**Subpart A Inspection Report
in Response to the February 14, 2014 WIPP Incident**

April 7 - 29, 2014

**U. S. ENVIRONMENTAL PROTECTION AGENCY
Office of Radiation and Indoor Air
Center for Waste Management and Federal Regulation
1200 Pennsylvania Avenue, NW
Washington, DC 20460**

September 2014

Figure 2: Typical DOE Ambient Air Sampler Configuration (location Carlsbad)

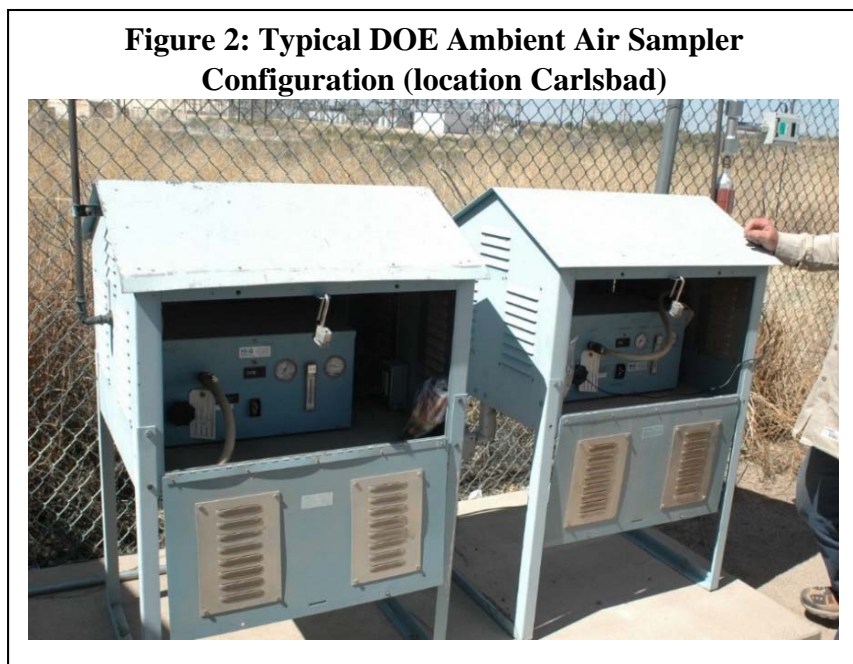
The physical positioning of several ambient air samplers needs to be improved for the samplers to function properly. The ambient air samplers located at the Carlsbad location were partially obstructed by a large outdoor shed and closely parked maintenance trucks, potentially preventing air flow from the desired 270 degree sampling area or even the 180 degree minimum sampling area. The presence of vehicles could also provide bias from vehicle emissions, which may interfere with collection efficiency. The newly established ambient air samplers located at Artesia, Loving, Hobbs and Eunice were all closely located to structures more than three times the height of the samplers (Figure 5). Each of these samplers should be moved to attempt to get a 270 degree sampling area away from buildings. In addition, samplers in Artesia and Eunice station were located next to regularly plowed farm land, which could reduce the collection efficiency of gathering the targeted radionuclides due to early loading of the sample filters with soil particulates. Lastly, the sampler in Artesia was placed under an exhaust vent for the adjacent fire station. Particulate exhaust from this vent may reduce collection efficiency.

This sampler should be moved away from this exhaust. These observations are made in consideration of 40 CFR Part 58, Appendix E, Probe and Monitoring Path Siting Criteria for Ambient Air Quality Monitoring. The samplers sited at WIPP Far Field, WIPP East, WIPP South, Mills Ranch, Smith Ranch, Southeast Control, Met Tower, Salt Hoist, Training Building and the WIPP Guard & Security Building were placed in excellent locations for sample collection.

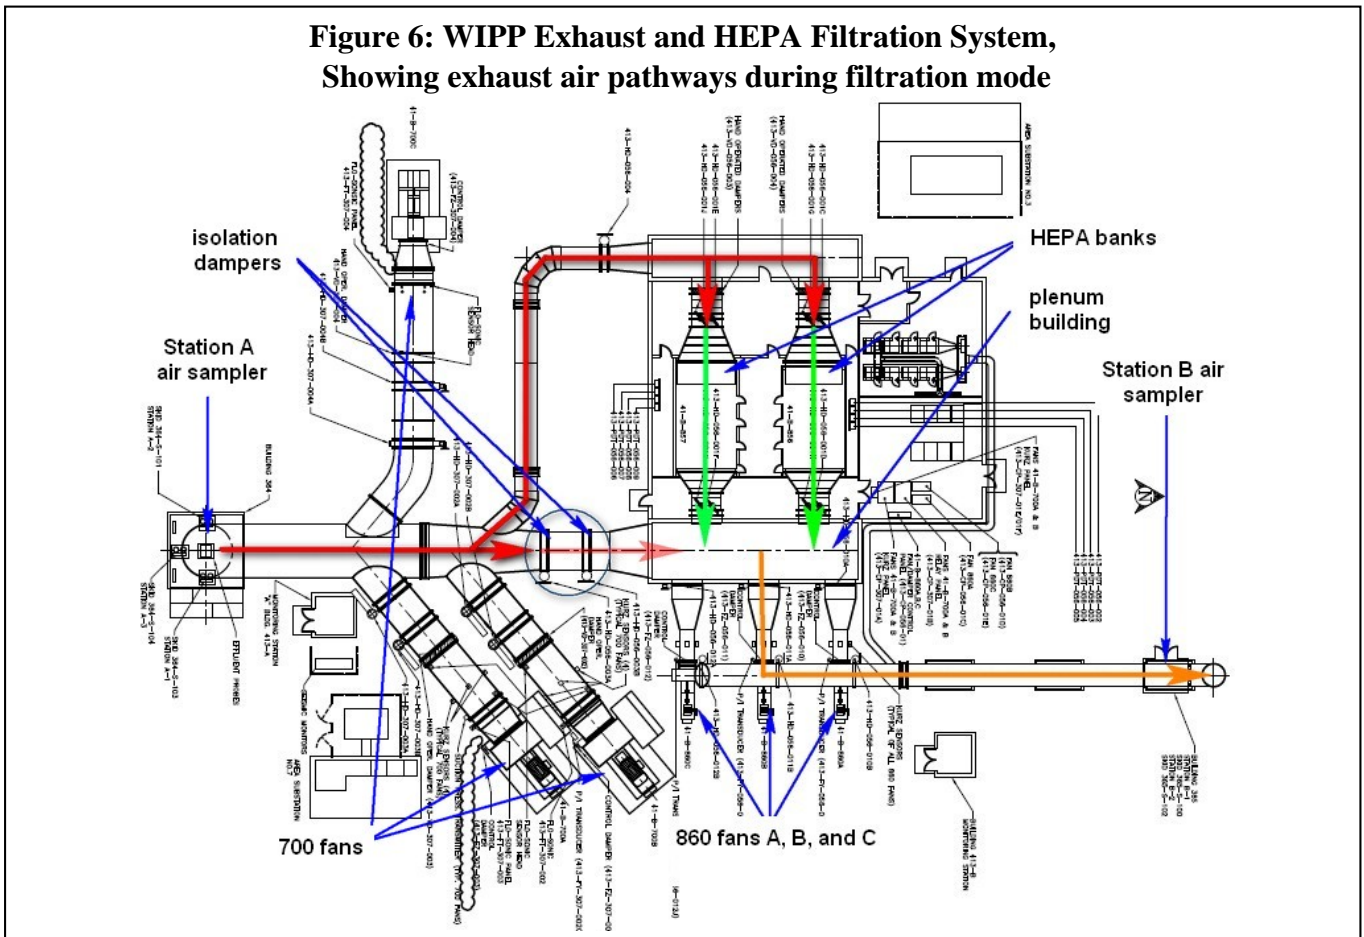
Based on EPA's observations, the HEPA filters continue to work effectively with the additional sealing by DOE to prevent leakage. However, DOE's Accident Investigation Report identifies several deficiencies in the ventilation system that, had they been corrected prior to the accident, would have further minimized the release. Specifically, the investigation concluded that "the unfiltered above ground release identified in Phase 1 of the investigation was preventable. The ventilation system has [HEPA] filter bypass dampers that represent a pathway of unfiltered exhaust into the environment. These isolation dampers are not suitable as a containment boundary and reduce the overall efficiency of the HEPA filter system." (AIB Phase 1 Report, p. ES-8) The investigation found that this situation originated in DOE's assumption that "only relatively smaller releases in the [underground]...were judged to be credible." As a result, "the damper design was not required to meet requirements in the nuclear industry ventilation code." This view of the potential for releases also contributed to a maintenance environment in which "there was significant degradation in the material condition of several ventilation system components identified that were not being aggressively pursued." (p. ES-2)

A major concern of EPA, prior to the inspection, was DOE's post-incident realization that the isolation dampers used to divert exhaust air into the HEPA filter banks were designed with a certain amount of leakage, allowing some effluent air to bypass the filters and be exhausted directly to the atmosphere via Station B. EPA placed a high priority on understanding the implications of this leakage. Because the HEPA filtration system is functioning as the primary defense against additional contamination escaping the underground, EPA also discussed maintenance of the system with the responsible personnel. EPA also inspected the equipment used to sample the exhaust air from both the underground facility and Waste Handling Building (WHB).
